# CITY OF ALBUQUERQUE

**Re: Broadstone Promenade Phase 17  
7400 San Pedro Dr. NE  
Permanent CO – Accepted  
Engineer's Stamp dated: 5-26-15 (D18D054A)  
Certification dated: 5-12-16**

## DRAINAGE CERTIFICATION

OVERALL  
GRADING AND DRAINAGE PLAN

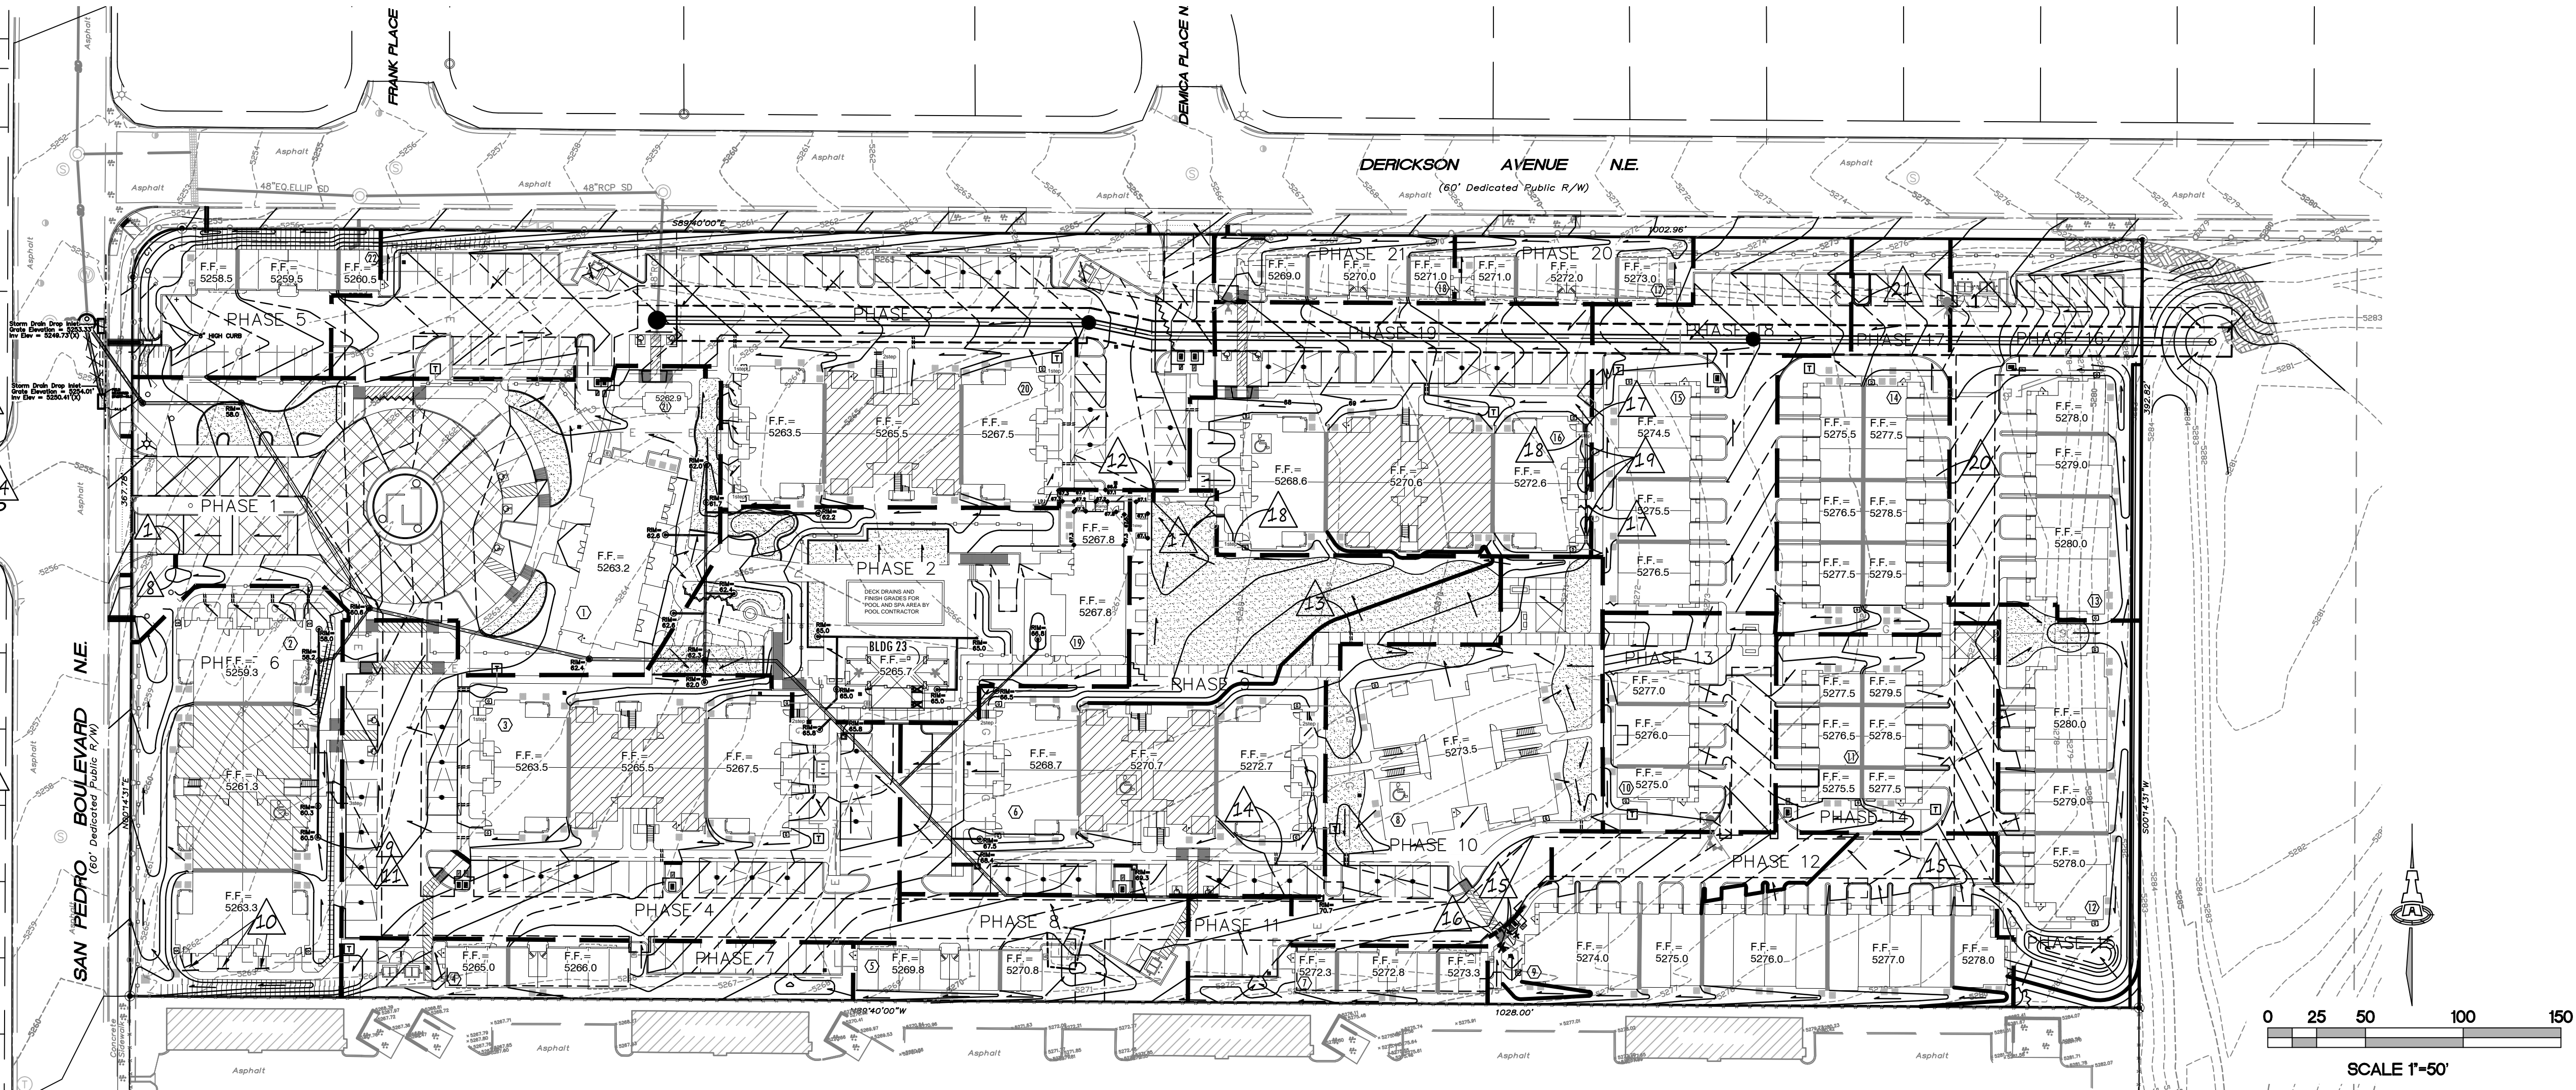
- △ 2 DRAIN PIPES INSTALLED

- △ STEP NOT CONSTRUCTED

- △ 12" VALLEY GUTTER CONSTRUCTED

**CG1.1**

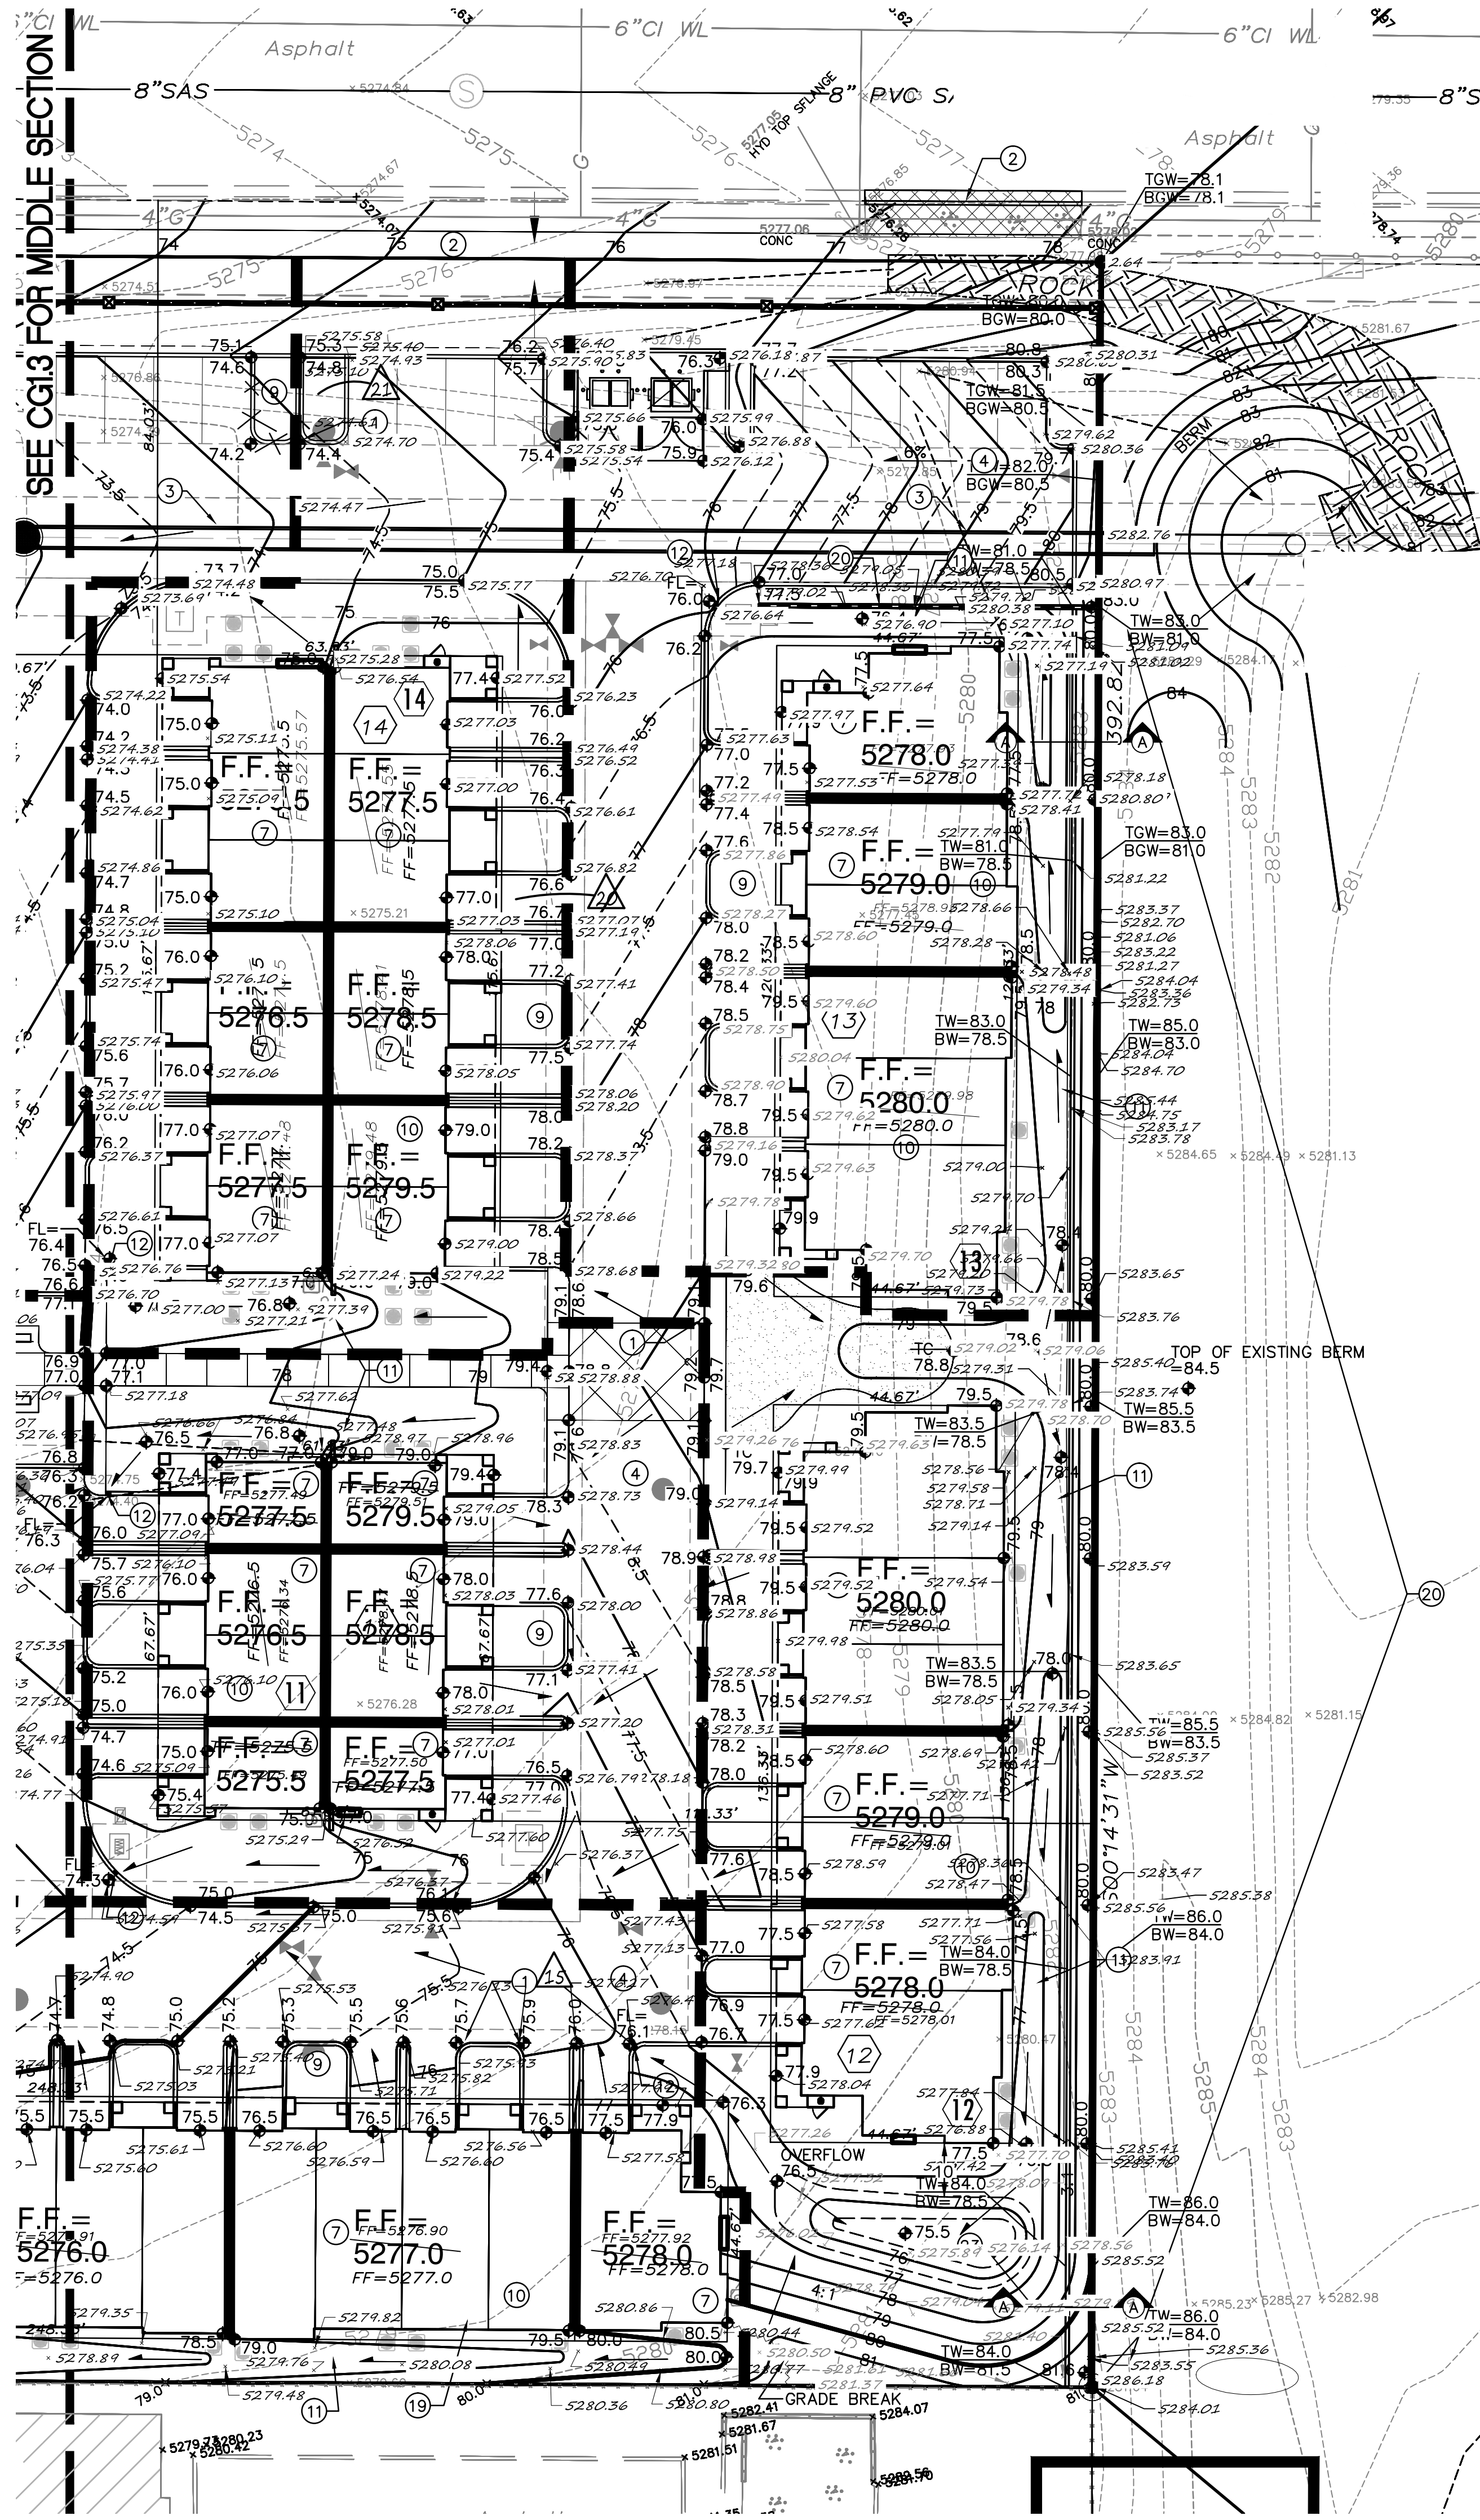
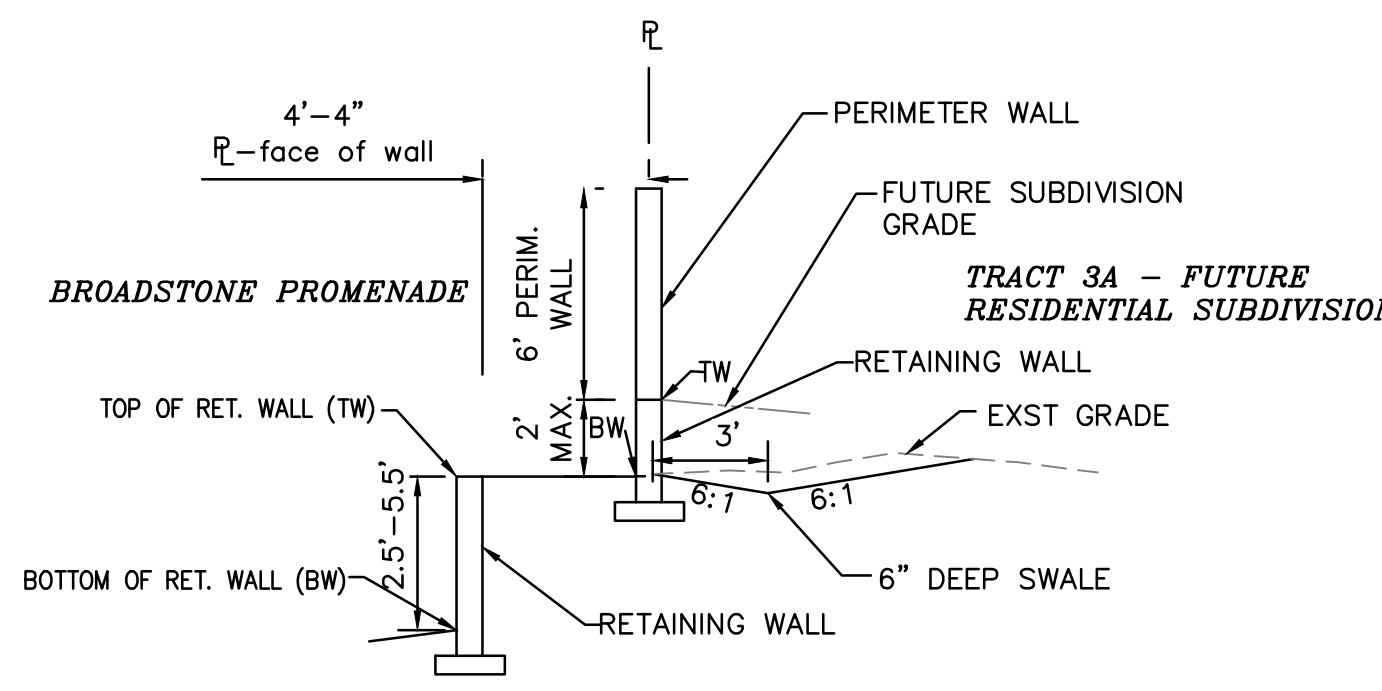
- △ DRIVEWAY SLOPE SHALL BE VERIFIED AND PAVING SHALL BE ADJUSTED IF NEEDED TO ENSURE THERE IS NO PONDING PRIOR TO FINAL CERTIFICATION.

- △ MEDIAN WAS SHIFTED EAST.
